Maharashtra Metro Rail Corporation Limited
(A joint venture of Govt. of India & Govt. of Maharashtra)
Nagpur Metro Rail Project - Phase 2

Corrigendum-II

Tender No: N2-010/C-04/2023 dated 07-Sep-2023

Name of Work: Design and Construction of Elevated Metro Viaduct of length 5.333 km between Ch. (-)289.668 m to Ch. (-)5622.577 m in Reach 4A of NMRP Phase-2

Revision No. **R02** Revision date **26/10/2023**

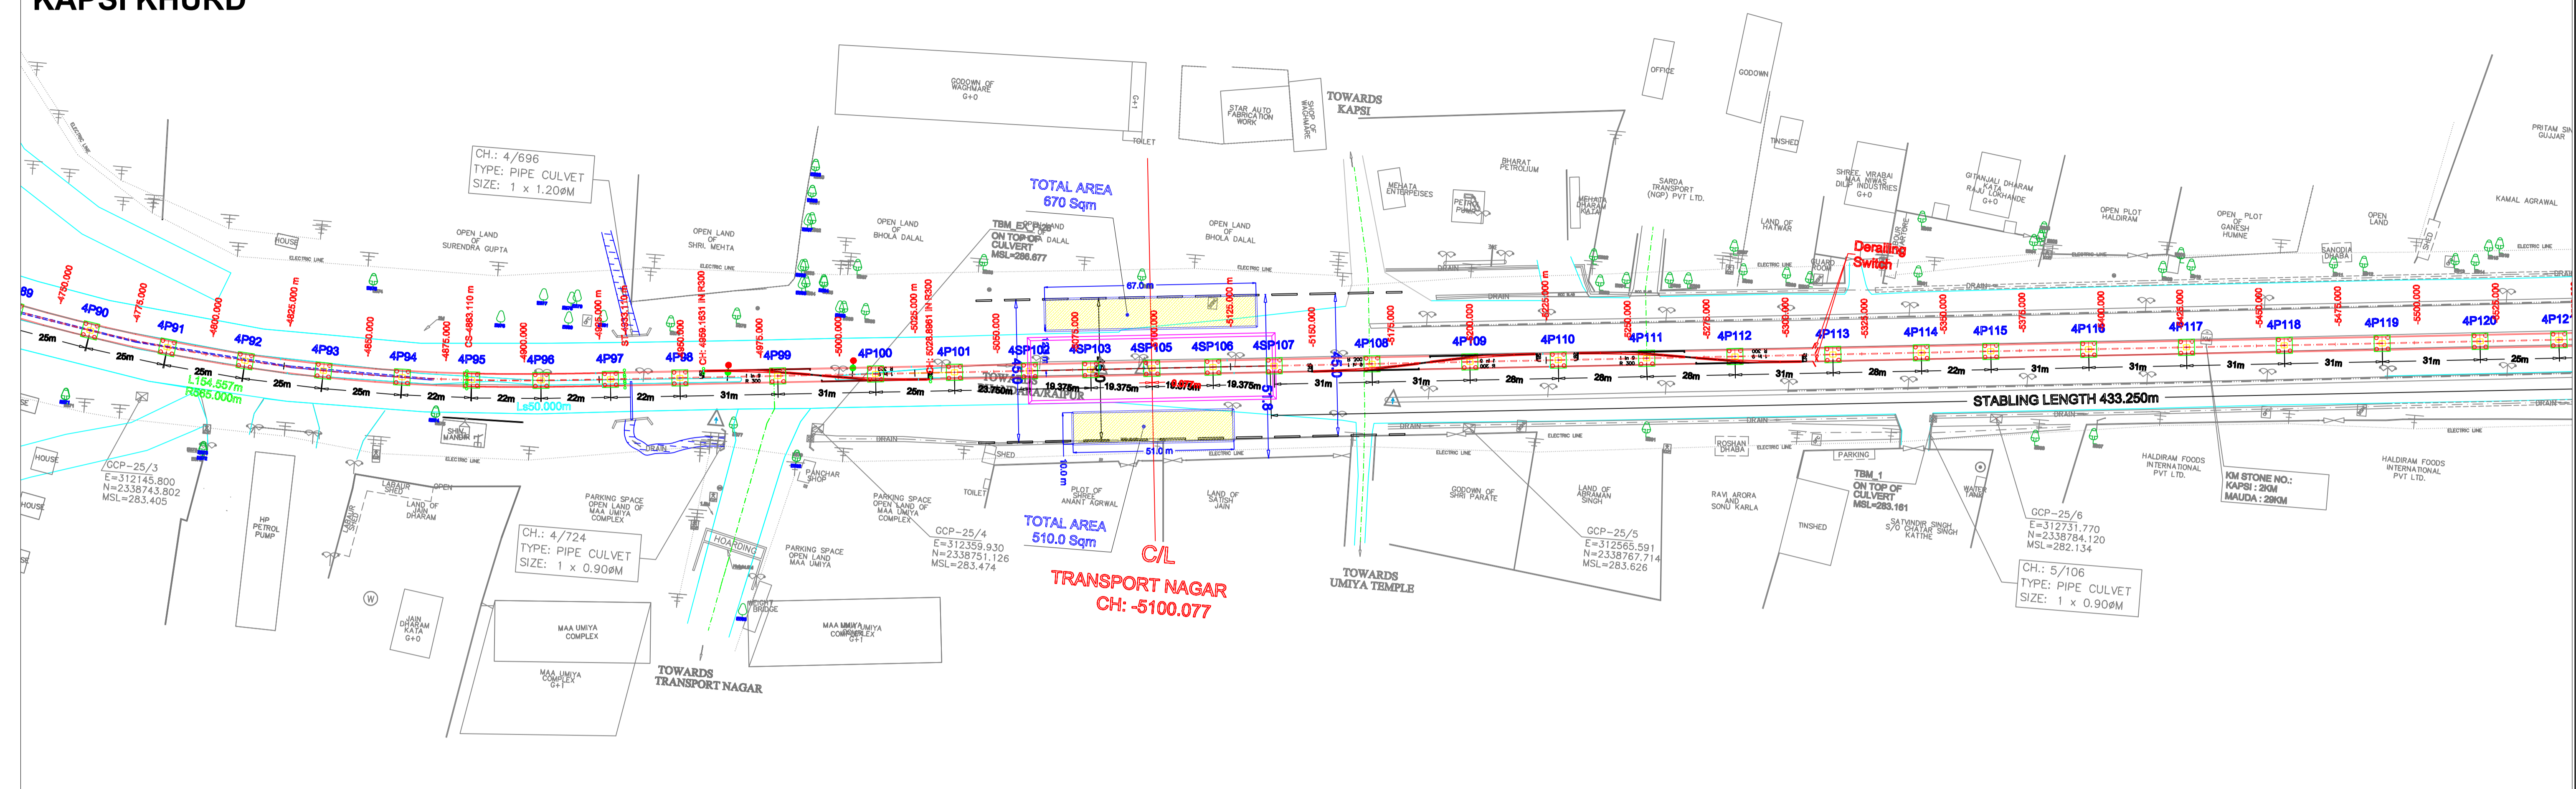
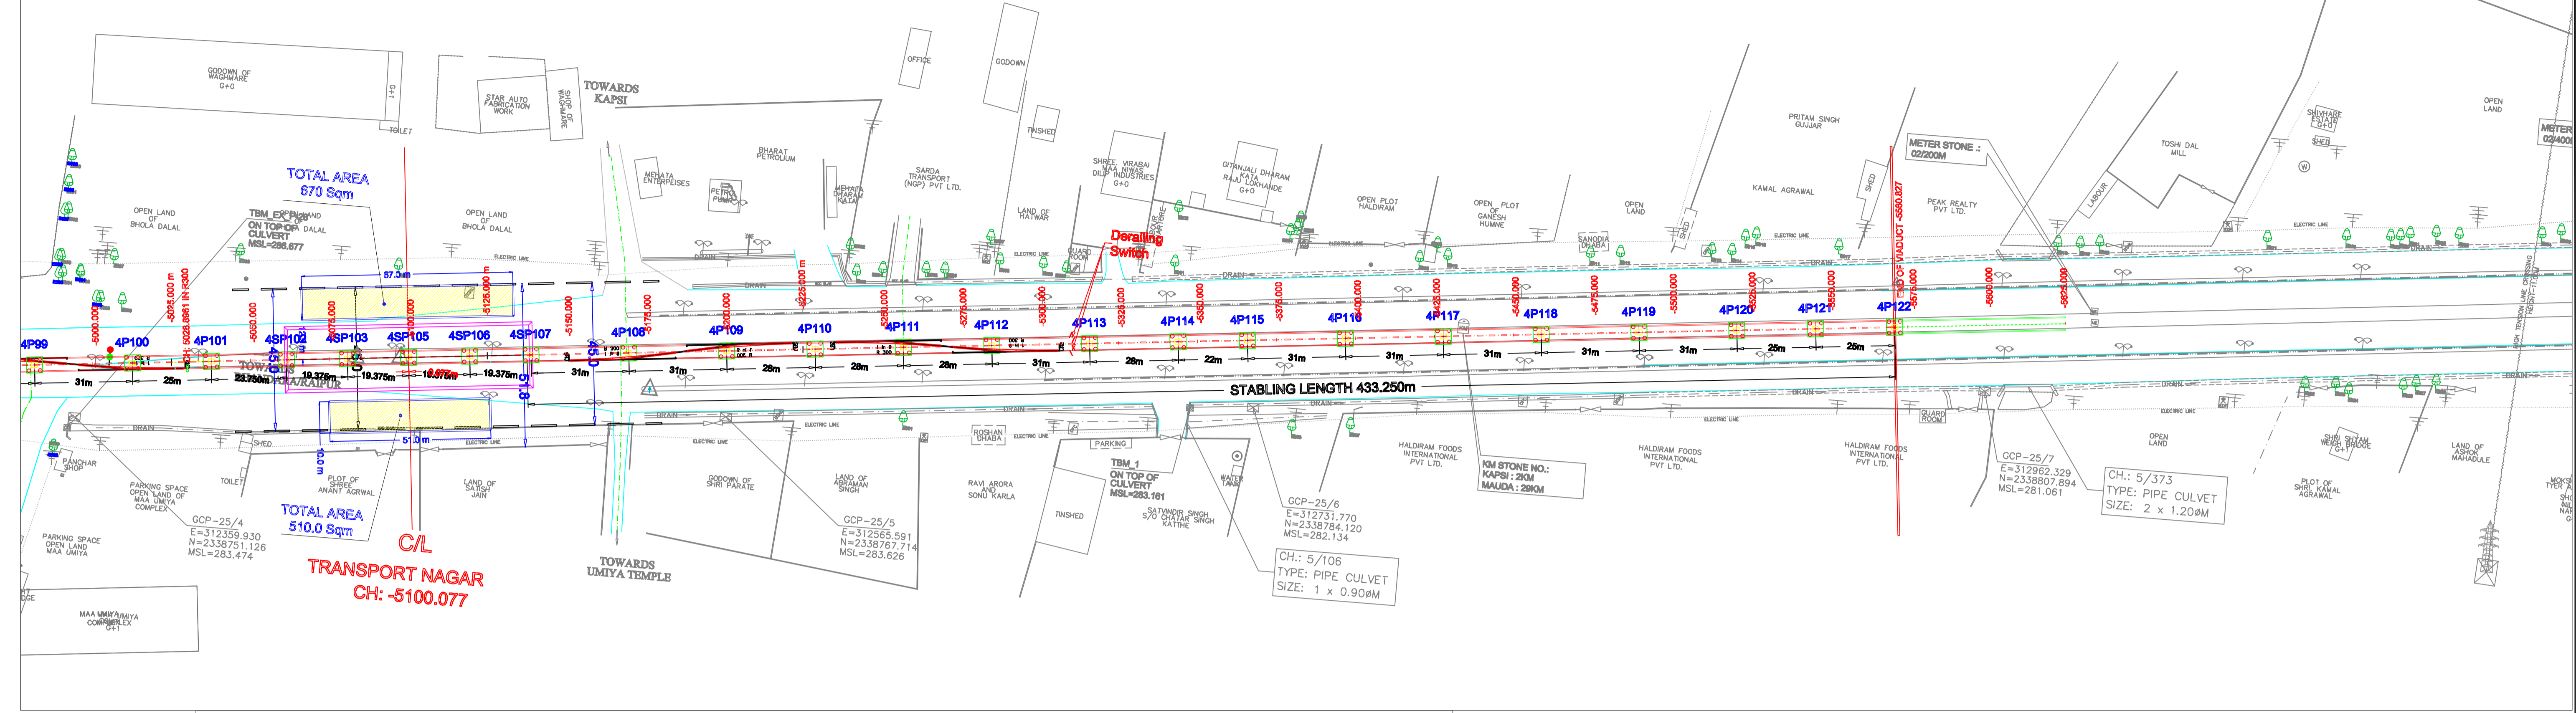
| Reference | Existing Provision | Revised Provision |
|--|---|---|
| Note no. 2 in GAD | Vertical profile as indicated in this tender drawing is based on GL/Road Level as surveyed during preparation of DPR in 2018. However, Contractor will have to ascertain its final value and maintain the requisite vertical clearance of 5.5m from existing/finished Road top level (as on date) to soffit level of Metro Superstructure. | Vertical profile as indicated in the tender drawing is based on GL/Road Level as surveyed during preparation of DPR in 2018. Maha-Metro Doesn't own any responsibility for the accuracy of the same, Contractor will have to ascertain its final value and maintain the requisite minimum vertical clearance of 5.5m from as built flyover Road top level (as on date of construction) in consonance with provision of IRC: 86-2018 from CH: (-)289.668 to (-)2250.000. Also, From CH: (-)2250 to CH: (-) 5560.827 shall maintain minimum vertical clearance of 5.8m from the existing road level. |
| GAD DWG NO. MM/PIg/NIT/NGP PH-II/4A/R1/2023 | GAD - DWG NO. MM/PIg/NIT/NGP/PH-II/4A/R1/2023 (Sheet 1 to 8) dated 12-July-23 | Revised Drawings are attached with this corrigendum: GAD - DWG NO. MM/PIg/NIT/NGP/PH-II/4A/R2/2023 (Sheet 1 to 8) dated 26-Oct-23 |
